*Bridge Preliminary Design Report
Addendum*

**Ramp C over Norfolk Southern Tracks
SCI-823-1603**

**SCI-823-10.13
PID No. 79977**

to:	James A. Brushart, District 9 Deputy Director	date:	Apr. 15, 2008
from:	Timothy J. Keller, Administrator, Office of Structural Engineering by: Ananda Dharma, P.E.		
subject:	SCI-823-10.17; PID 79977; Bridge No. SCI-823-1603; Ramp C over Norfolk Southern Railroad; Preliminary Design Review

RAILROAD MINIMUM CLEARANCE REQUIREMENTS

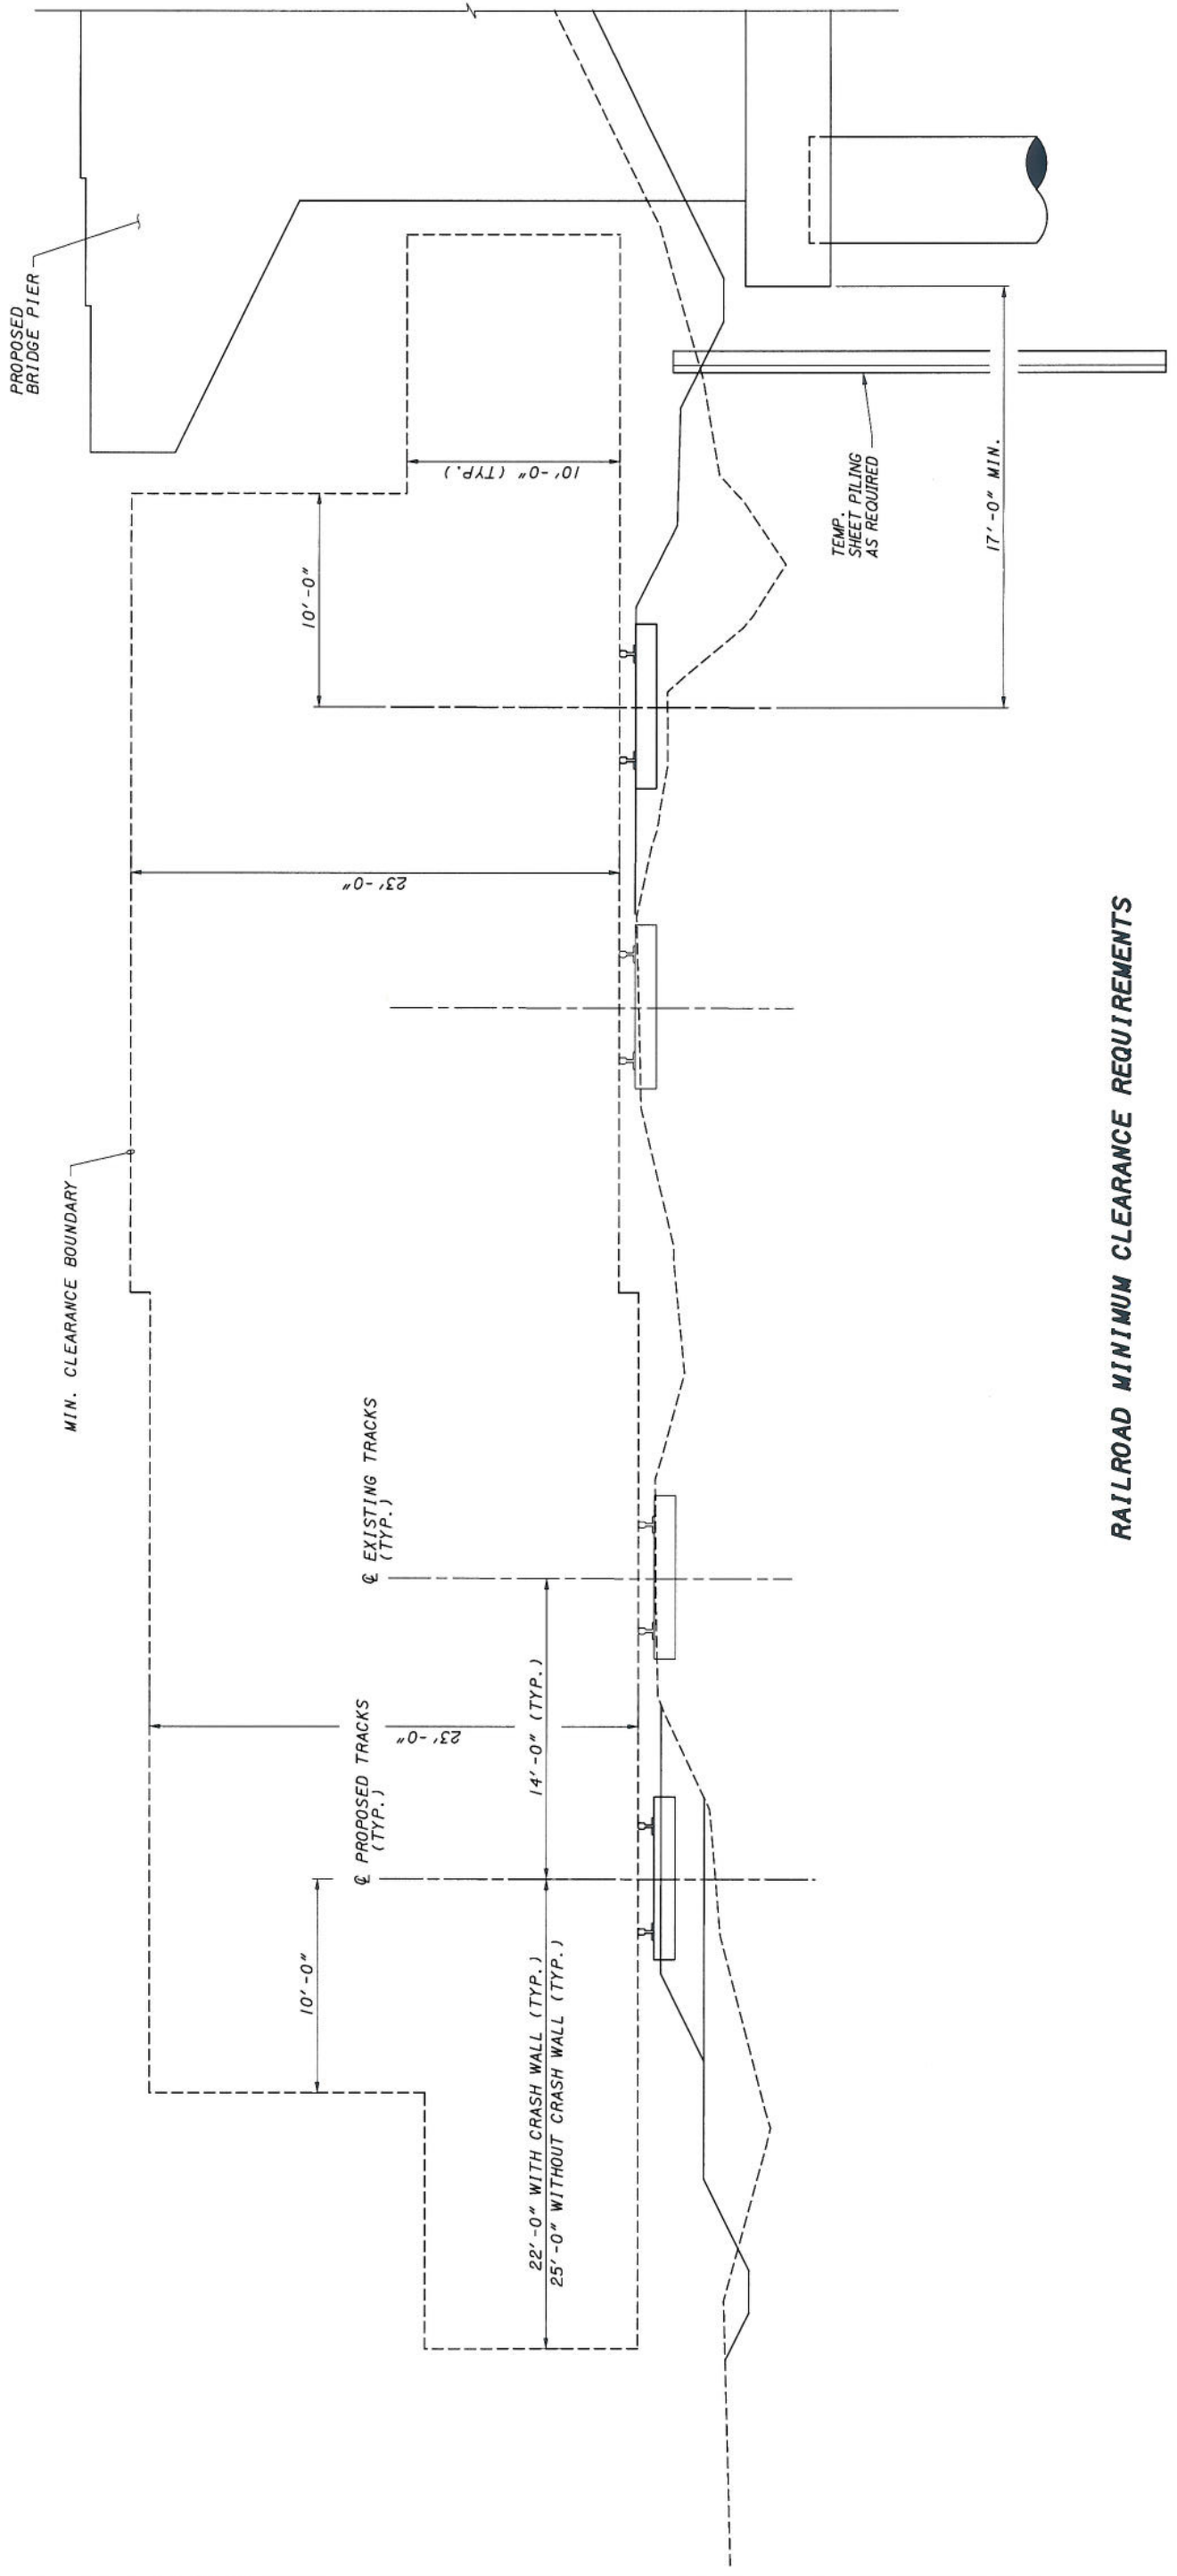
One thing of note is the location of the T-type pier. Our understanding is that as long as the pier stem is a minimum of 22'-0" from the centerline of the track and 10'-0" high, the pier cap can extend inside of the 22'-0" clearance envelope. Again, due to the two new tracks and the curvature of the ramps, our goal is to shorten the span lengths as much as possible.

As discussed, your interpretation is somewhat confused. The T portion of the cap can not be any closer to the track than 10'-0" if bottom portion is less than 23'-0" above top of rail.
